**Re: Aspire Public School, 1009 66<sup>th</sup> Avenue, Oakland, California – USEPA November 13, 2009 Approval of Polychlorinated Biphenyls' Cleanup Notification Under Toxic Substances Control Act – Request for Cap Modification**

Proposed Toxic Substance Control Act (TSCA) Cap for Modular Buildings –  
Former Pacific Electric Motors Facility, 1009 66th Avenue, Oakland, California

SUBJECT: Aspire - TSCA CAP  
Rat Slab Design  
For Modular Buildings

BY: Rong DATE: 3/31/18  
CHKD: DATE:  
Figure 3

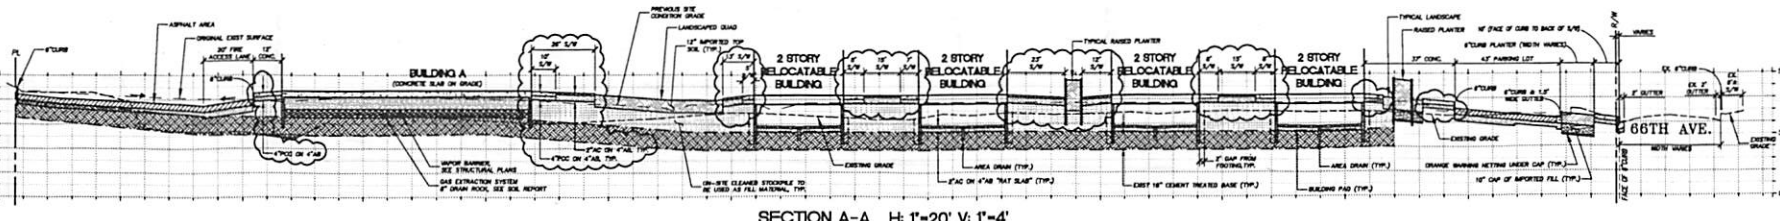
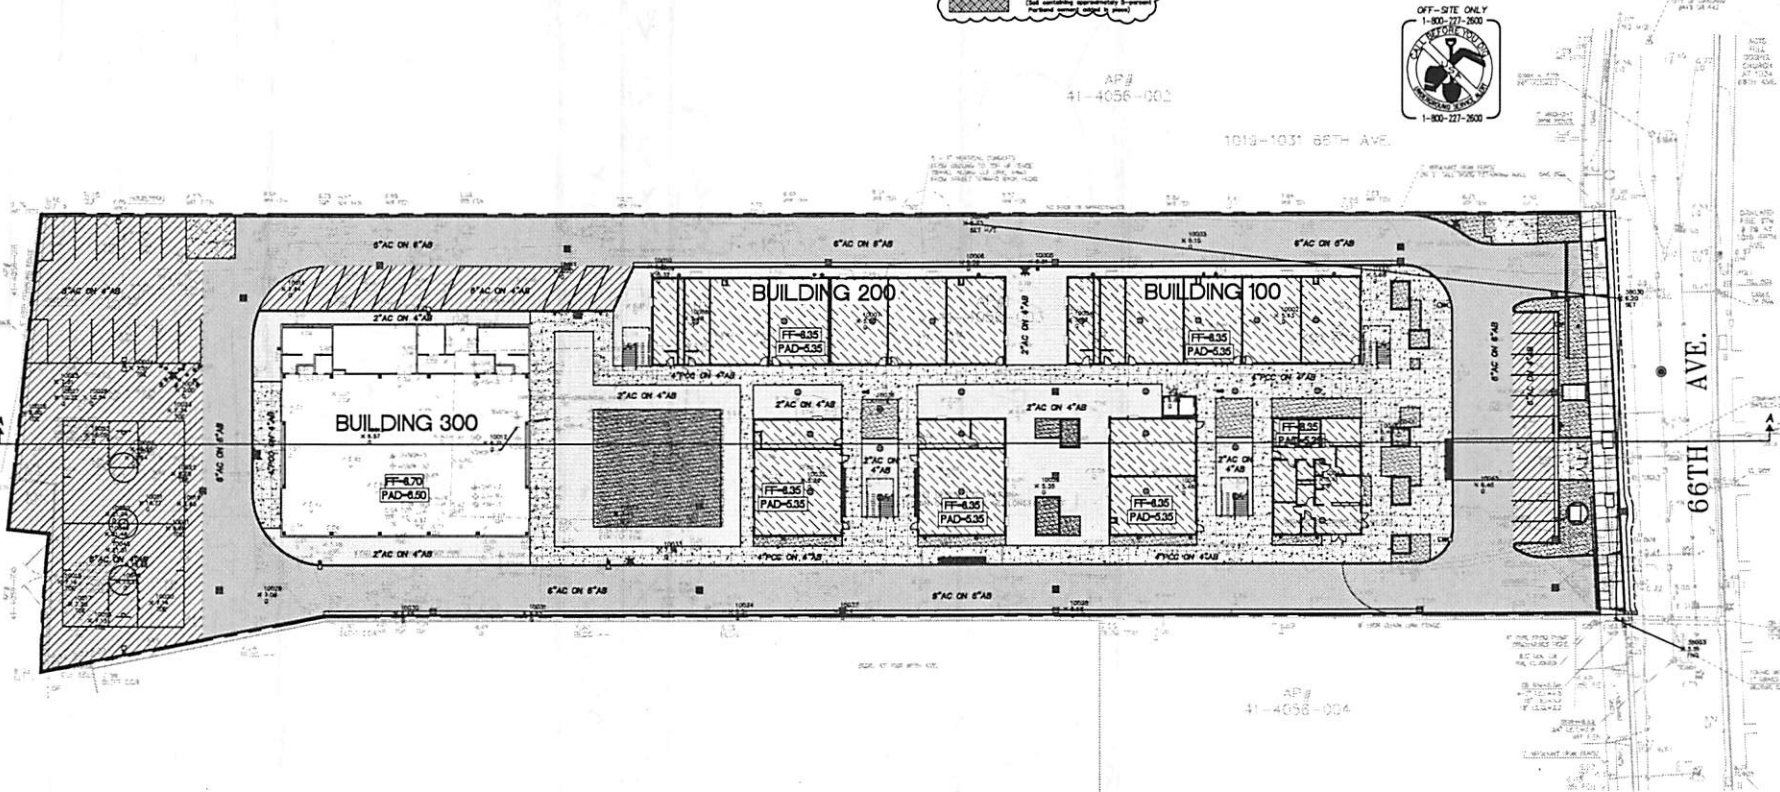
In the attached letter, Arcadis is proposing a modified design for the rat slabs over which the schools modular buildings will be installed. These modified rat slabs are proposed as an alternate cap design for the portion of the site where the modular buildings will be located and such proposed cap differs from the concrete cap required in 40 CFR 761.61(a)(7). The proposed alternate cap (modified rat slab) is a 6-inch-layered cap that will be constructed atop 18-inches of cement-treated native soil contaminated with residual PCB levels. The 18-inch soil layer is underlain by native soils. The proposed alternate cap consists of a 4-inch thick layer of imported base rock atop the 18-inch cement treated soils and a 2-inch thick Portland cement concrete layer atop the base rock layer.

The details regarding the proposed design for the rat slabs is illustrated on hand drawn Figure 3. Figure 2 provides a summary of the design for the proposed rat slabs as well as the revised TSCA cap for the other portions of the Site. The locations of the modular buildings, also described as relocatable buildings are presorted on Figure 2. ARCADIS will provide a request to approve the revised TSCA cap for the other portions of the Site under separate cover.

As discussed between representatives of ARCADIS and U.S.EPA on March 29 and 31, 2011 the proposed TSCA Cap design for the rat slabs will be comprised as follows (from the bottom up):

- Native soil
- 18 - Inches of cement treated native soil
- 4- Inches of imported aggregate base rock and
- 2- Inches of Portland cement concrete

We are approving the proposed design for the alternate cap (modified rat slab) under the TSCA regulations in 40 CFR 761.61(c) (risk-based cleanup option). We believe this alternate cap is still protective of human health and the environment provided that required maintenance and repairs are conducted as required in Condition 9 of the November 13, 2009 approval. The rat slab is a portion of the site-wide cap required for the Aspire site in USEPA's November 13, 2009 conditional approval of the October 23, 2009 Notification of PCB cleanup at the Aspire site. This approval modifies a portion of the site-wide cap required in Condition 8 of USEPA's November 13, 2009 letter. This approval does not modify Condition 9 in USEPA's November 13, 2009 Notification approval that requires maintenance and repair of the cap in perpetuity. The requirements in Condition 9 are equivalent and consistent with the requirements in 40 CFR 761.61(a)(8).
